Best Buy Premium Design Center

Conversion

MAVD TO MDC (PDC)

Plan outline for converting MAVD electronics to MDC (aka PDC) configuration

827-037-1 SPEAKERS 17-40
FRONT RIGHT/9-16 REAR LEFT

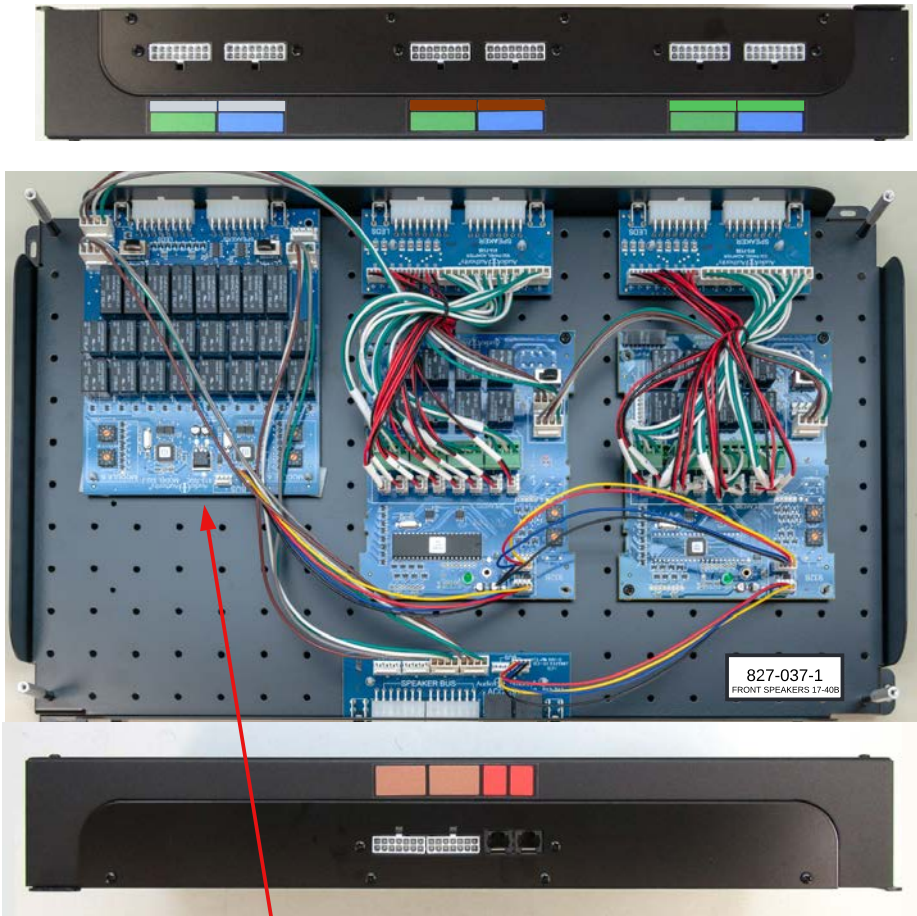
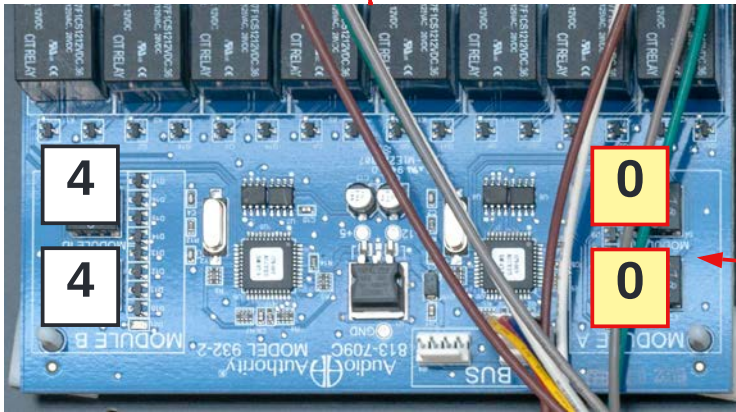
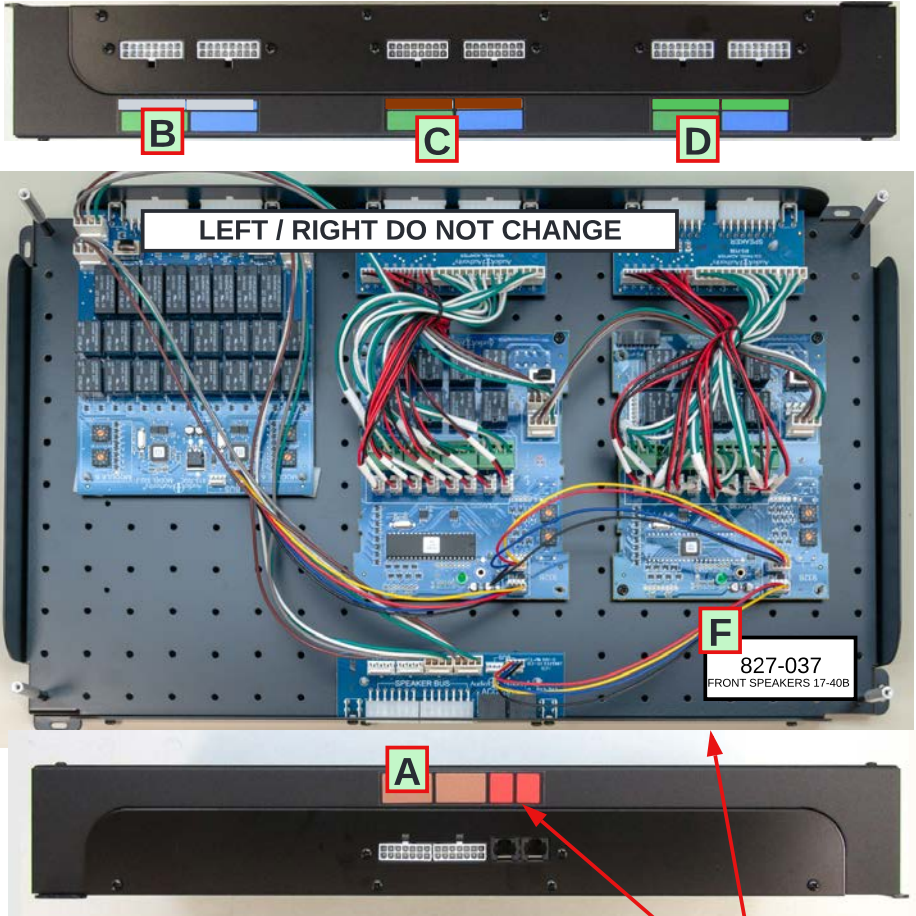
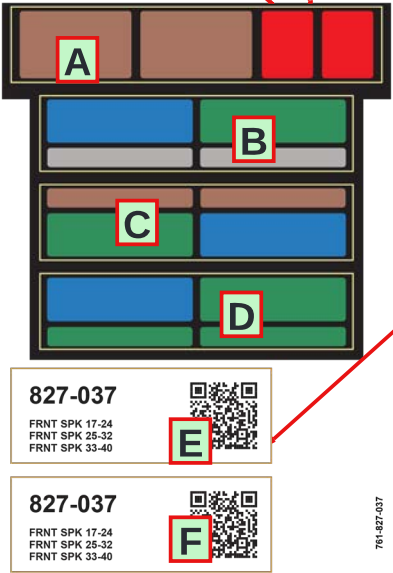
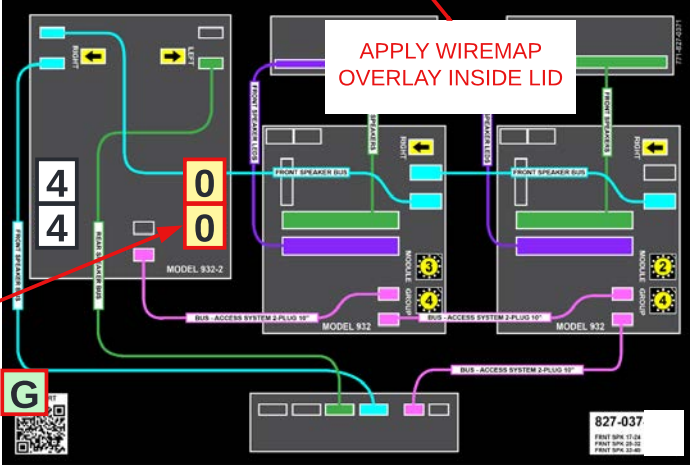
NEW ADDRESS
SETTING = 0 0

REPLACE OERLAY A-D
ONLY IF MISSING OR
DAMAGED

APPLY NUMBER
OVERLAYS INSIDE
AND OUTSIDE

NEW ADDRESS
SETTING = 0 0

HOW TO CHANGE 827-037-1
TO 827-037 (SPEAKERS 17-40B)
REPLACE OVERLAYS AND **CHANGE ADDRESSES** AS NOTED

827-033-1 SPEAKERS 17-40 FRONT
LEFT/9-16 REAR RIGHT

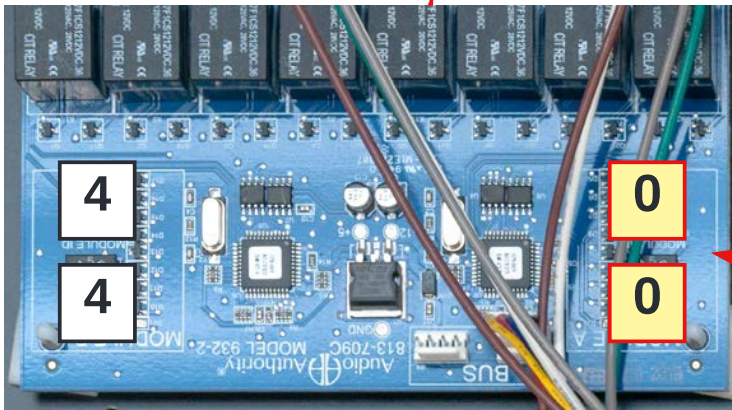
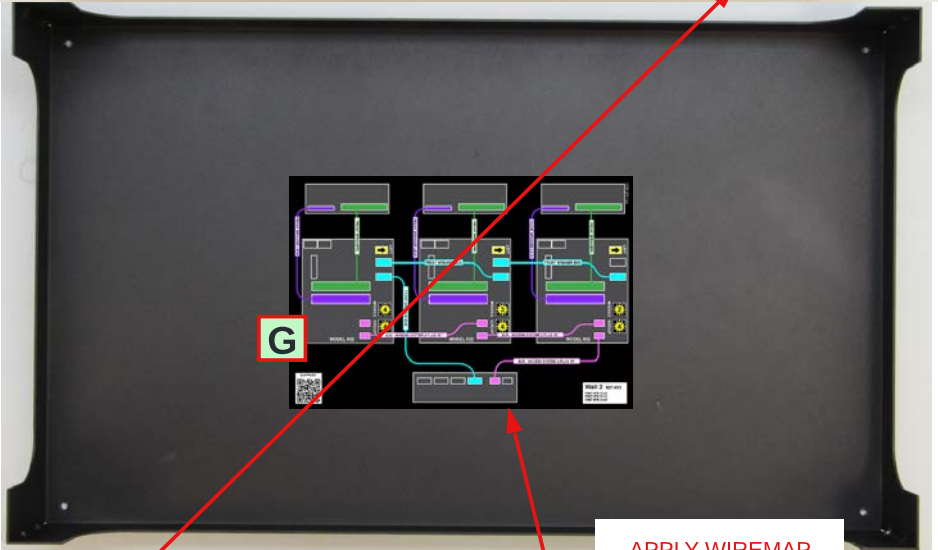
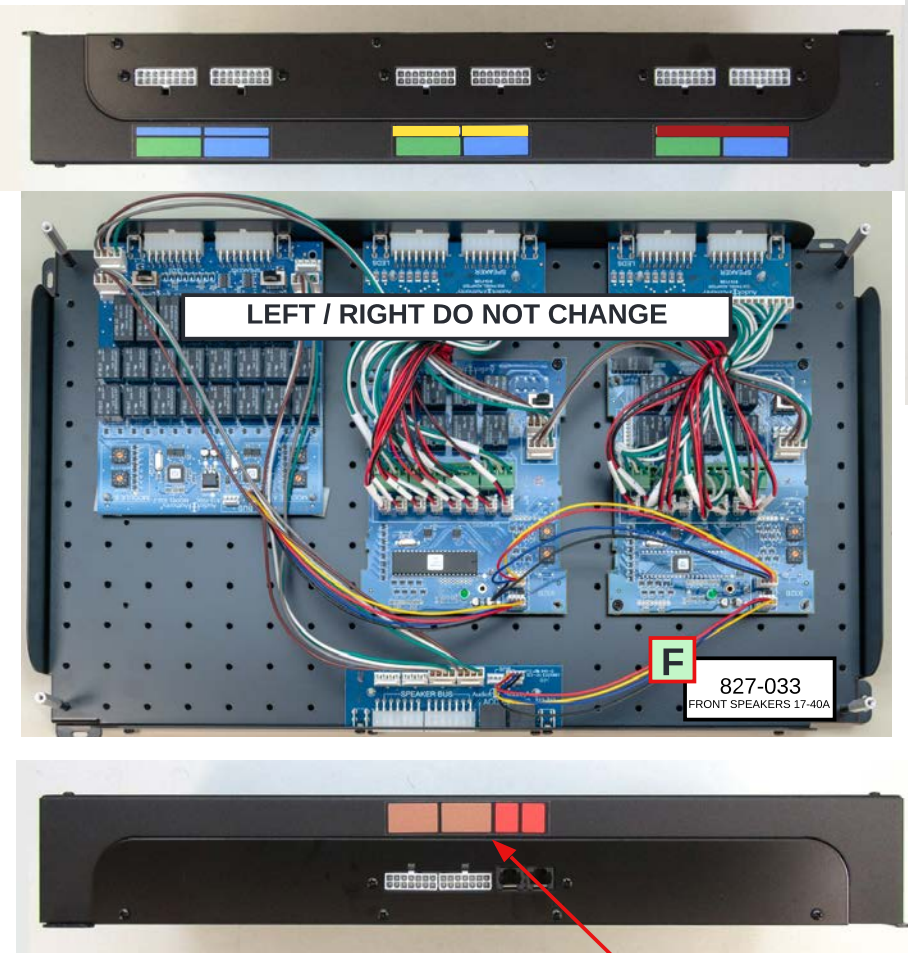
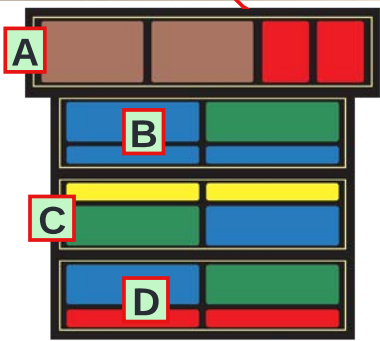
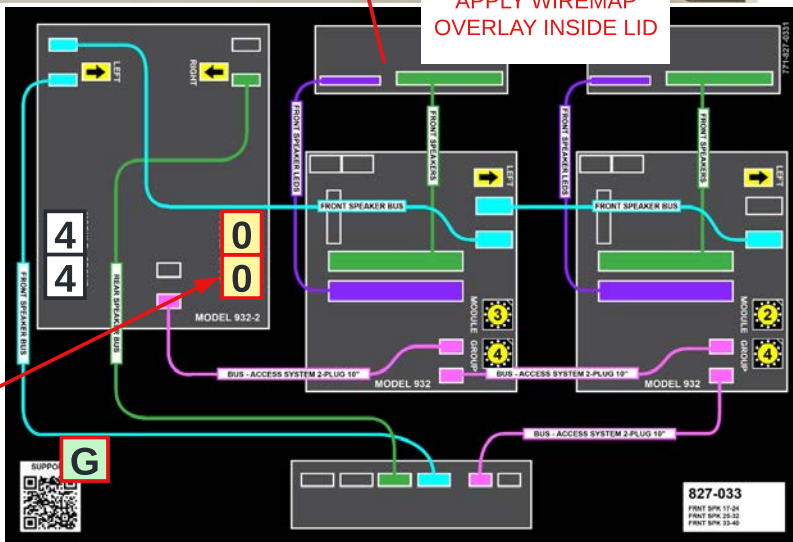
**NEW ADDRESS
SETTING = 0 0**

APPLY NUMBER
OVERLAYS ON BASE
AND COVER

REPLACE OVERLAY
A-D ONLY IF MISSING
OR DAMAGED

**NEW ADDRESS
SETTING = 0 0**

**HOW TO CHANGE 827-033-1
TO 827-033 (SPEAKERS 17-40A)**
REPLACE OVERLAYS AND **CHANGE ADDRESSES** AS NOTED

827-040-1
REC 17-20

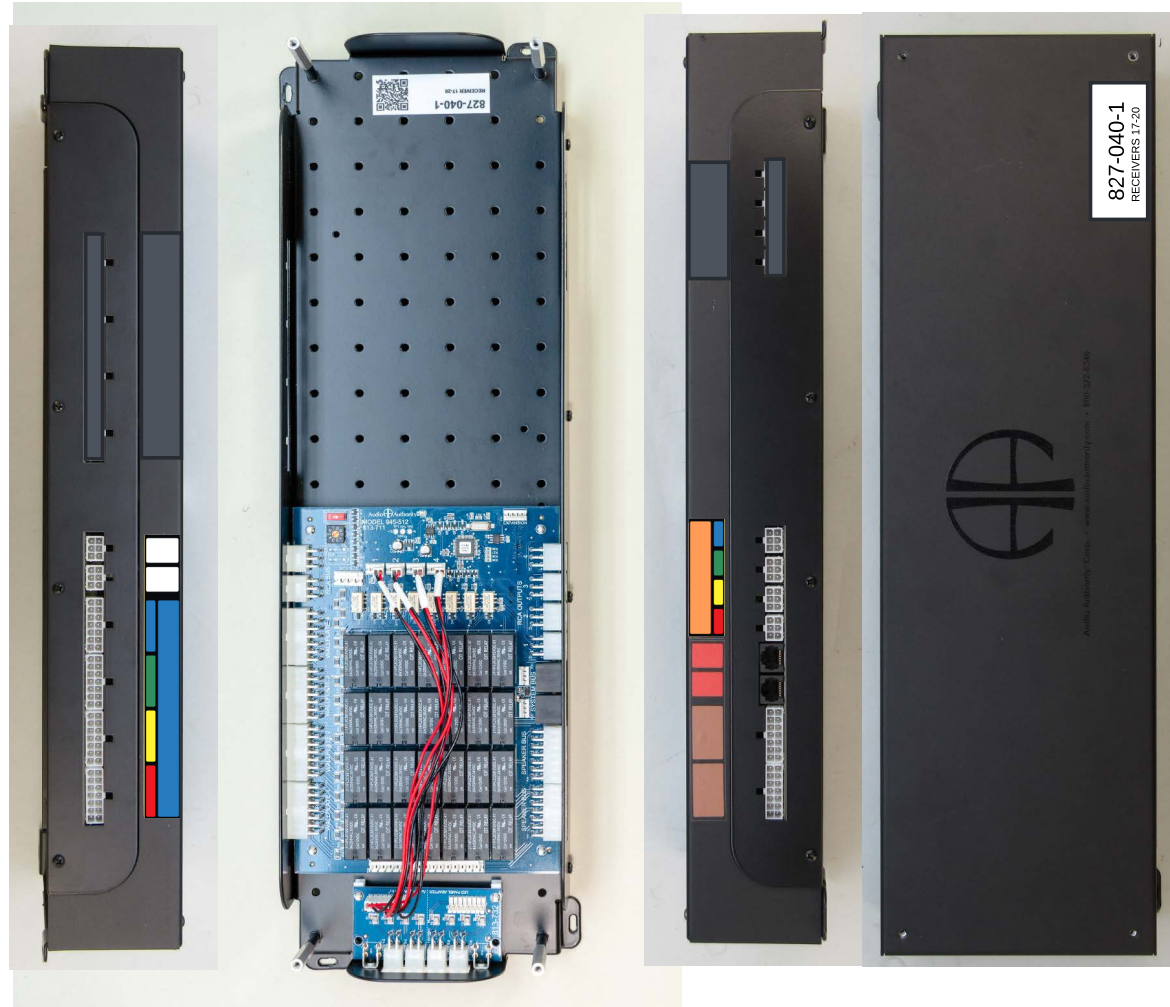
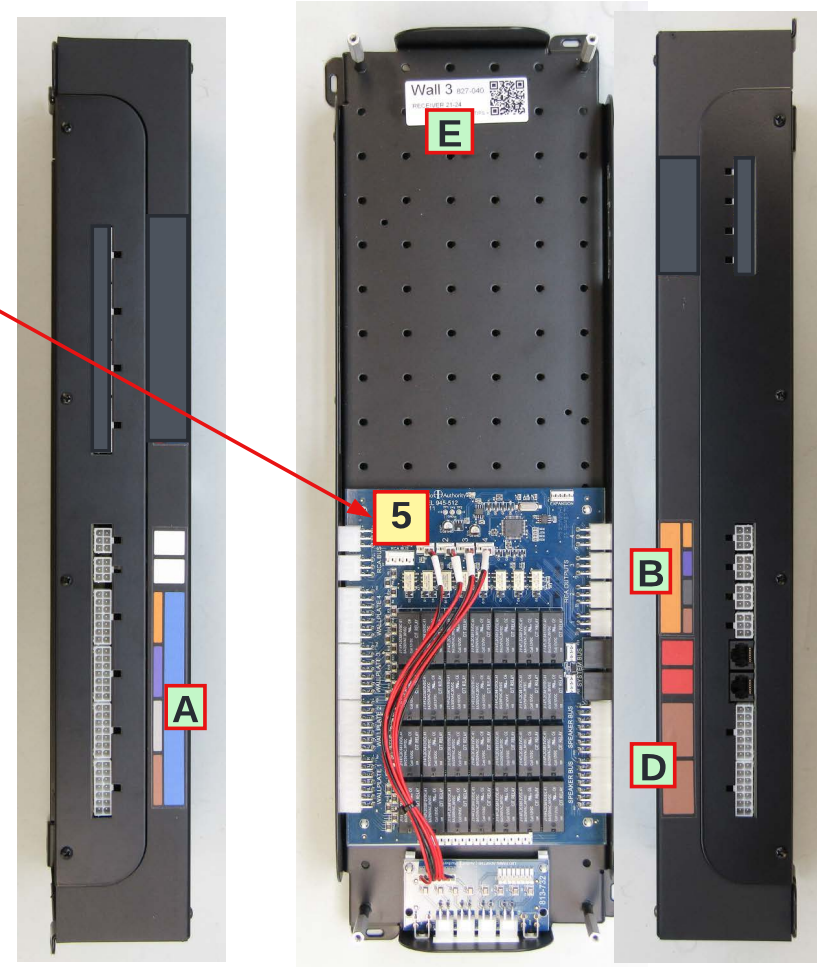
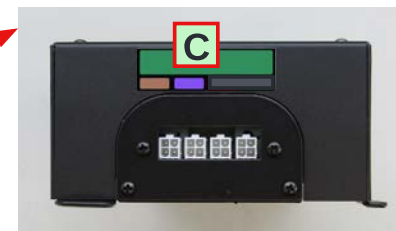
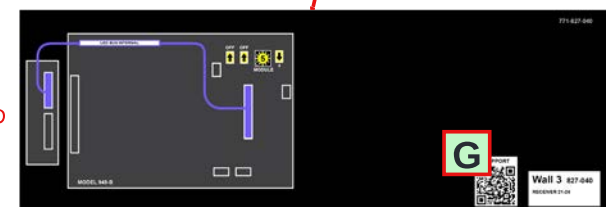
NEW ADDRESS
SETTING = 5

APPLY COLOR CODE
OVERLAYS ON
OUTSIDE OF LID

APPLY NUMBER OVERLAYS
ON BASE AND LID

APPLY WIREMAP
OVERLAY INSIDE LID

HOW TO CHANGE 827-040-1 TO 827-040 (RECEIVERS 21-24)

REPLACE OVERLAYS AND **CHANGE ADDRESSES** AS NOTED ABOVE

827-045-1 SPEAKERS 41-48A SPEAKERS 73-86A

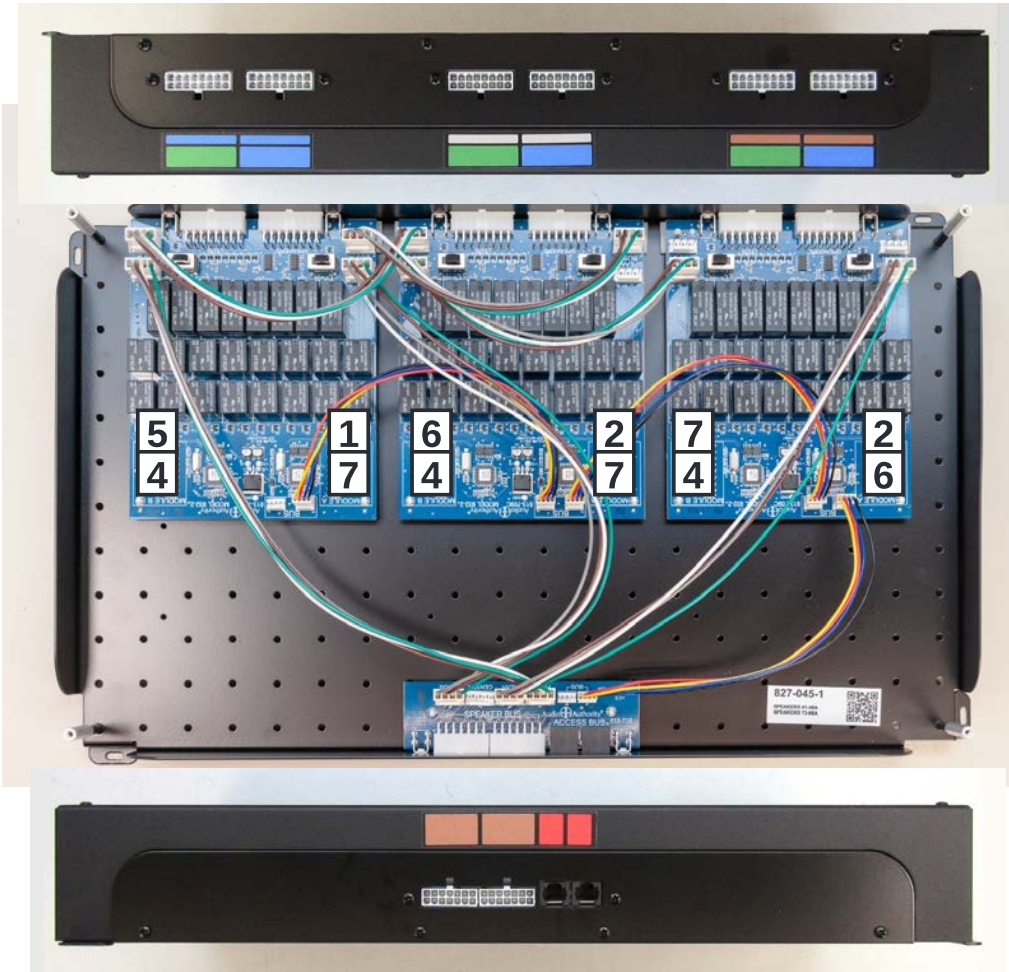
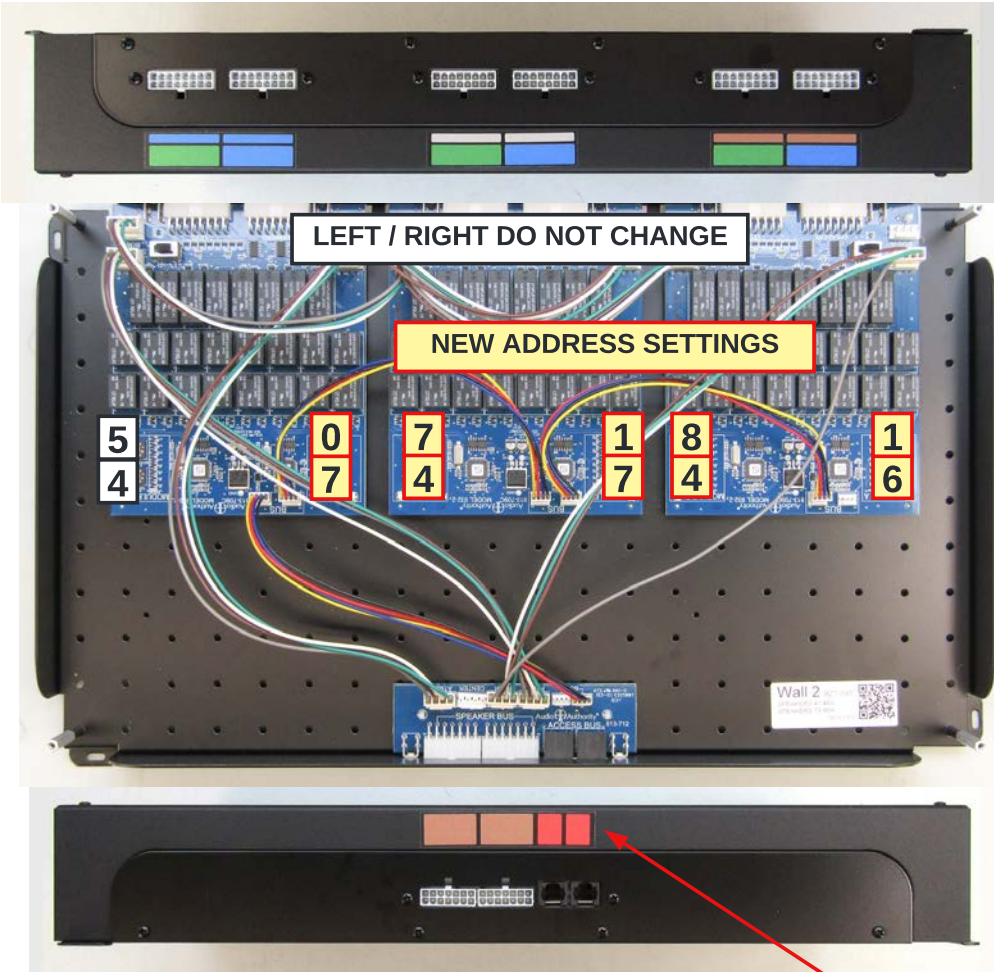
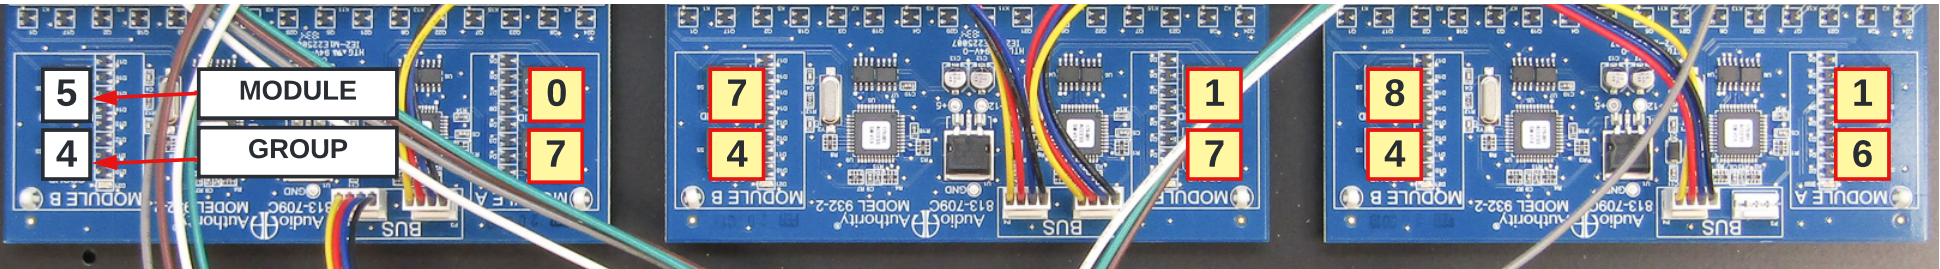
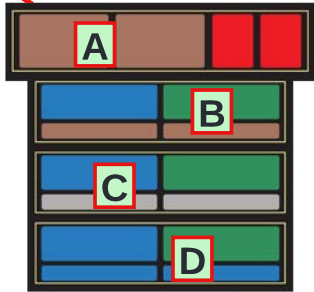
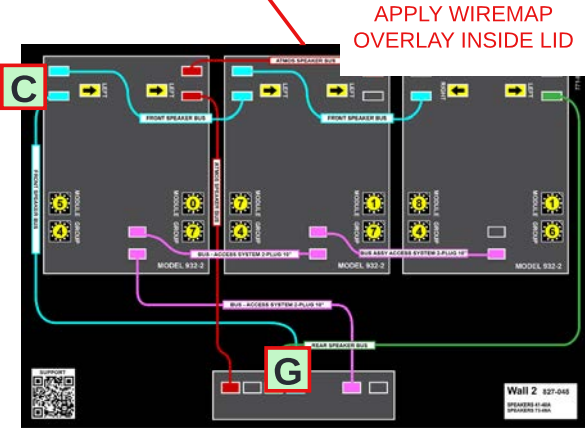
NEW ADDRESS SETTINGS

REPLACE LABELS A-D
ONLY IF MISSING OR
DAMAGED

APPLY
NUMBER
OVERLAYS

HOW TO CHANGE 827-045-1
TO 827-045 (SPEAKERS 41-48A/73-86A)
REPLACE OVERLAYS AND **CHANGE ADDRESSES** AS NOTED ABOVE
